**FEDERAL AVIATION ADMINISTRATION
AIRWORTHINESS DIRECTIVES**

LARGE AIRCRAFT

BIWEEKLY 2012-05

Figure 1
LH side shown
RH side opposite

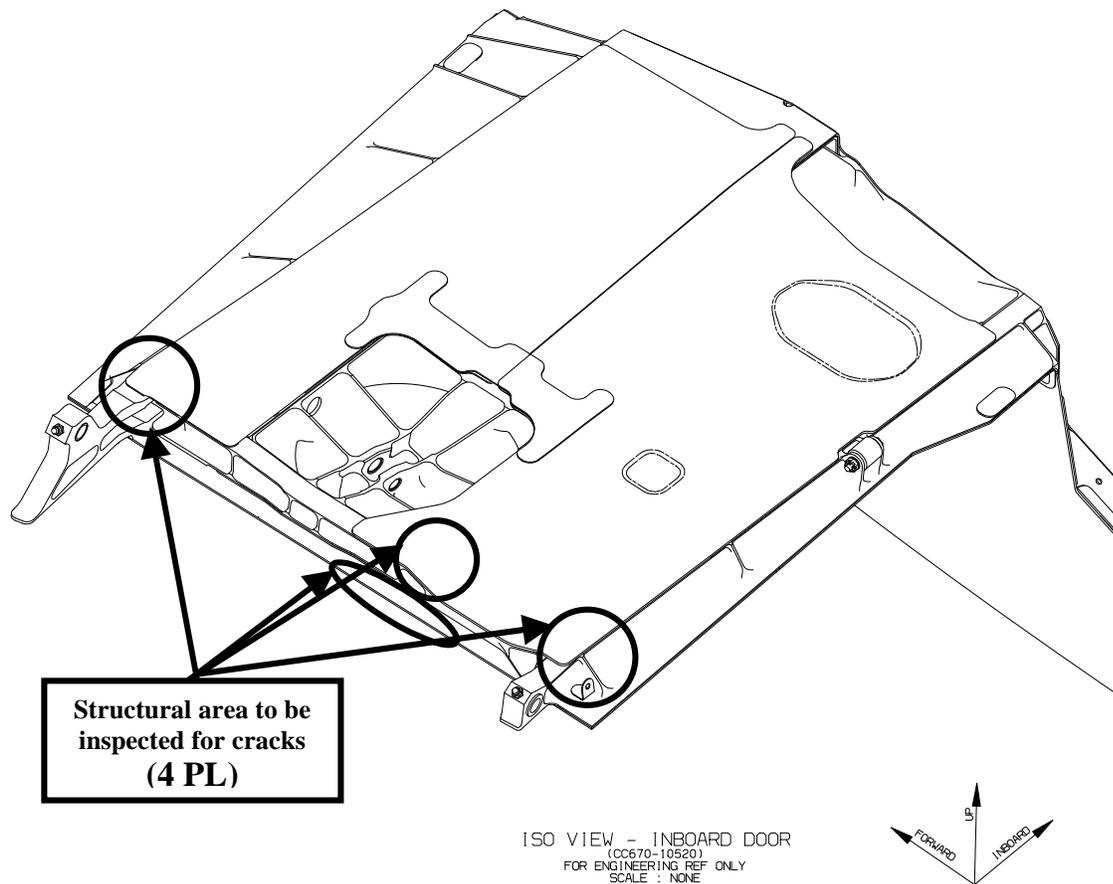
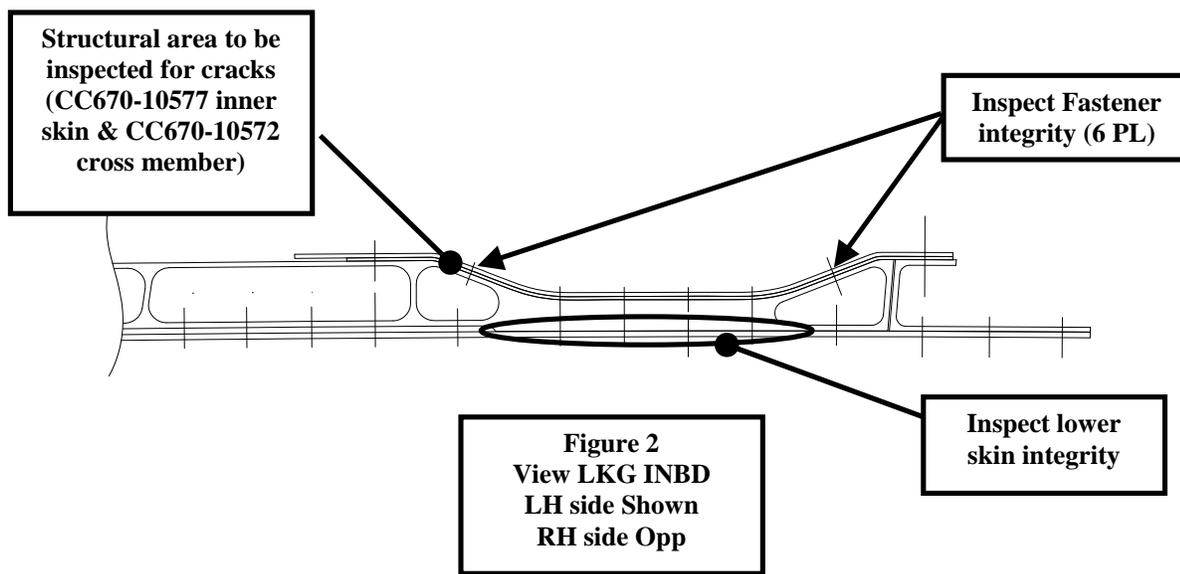
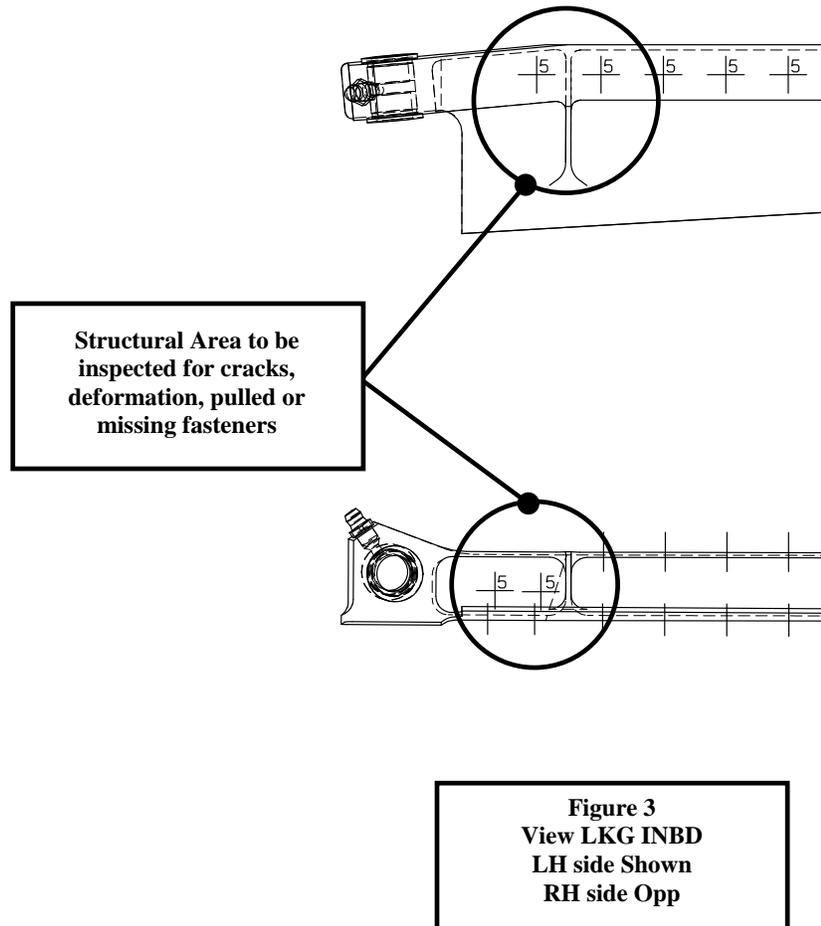
(1) Inspect the cross member, P/N CC670-10572, of the MLG door lower panel for cracking or deformation, in accordance with Figure 2 of this AD.

(2) Inspect the inner skin, P/N CC670-10577, of the MLG door lower panel at the cross member (P/N CC670-10572) for cracking or deformation, or pulled or missing fasteners, in accordance with Figure 2 of this AD.

(3) Inspect the outer skin, P/N CC670-10574, of the MLG door lower panel at the cross member (P/N CC670-10572) for cracking or deformation, or pulled or missing fasteners, in accordance with Figure 2 of this AD.

(4) Inspect the forward member, P/N CC670-10570, and aft member, P/N CC670-10571, of the MLG door lower panel for cracking or deformation, or pulled or missing fasteners, in accordance with Figure 3 of this AD. Figures 1 through 3 of this AD follow.
